Service Bulletin

Bulletin No.: 22-NA-008

Subject: Malfunction Indicator Lamp (MIL) Illuminated, Reduced Engine Power Message on Drivers Information Center (DIC) - DTCs U060F, U1346, P0101, P0102, P1101 and/or P14B6 Set

Brand:	Model:	Model Year:		VIN:		Engine:	Transmission:
		from	to	from	to		
Buick	Encore GX	2020	2022	SOP	KL4MMDS2XPB000138		
Chevrolet	Trailblazer (VIN M)	2021

6274274

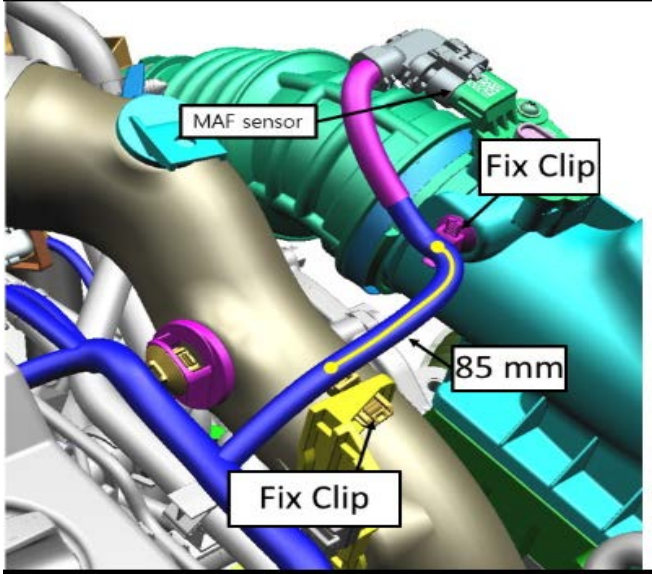
<p>Correction</p>	<p>Inspect the 2nd retainer back from the MAF sensor with the engine running. If the zip tie is too tight the wire may break at the zip tie during acceleration:</p> <ul style="list-style-type: none"> ⇒ Wiggle or pull on the harness to induce and identify a break inside the harness. ⇒ Repair circuit using published wire to wire repair for the MULTIFUNCTION INTAKE AIR SENSOR (MAF SENSOR). ⇒ Rewrap the wiring harness as required.

<p>Important: When replacing the wiring harness to the MAF sensor, The distance from the fixed clip mounted on the charge air cooler inlet air hose to the fixed clip mounted on the air cleaner housing must be 85 mm (3.4 in) as indicated in the graphic above, to allow for proper flex on acceleration.</p>
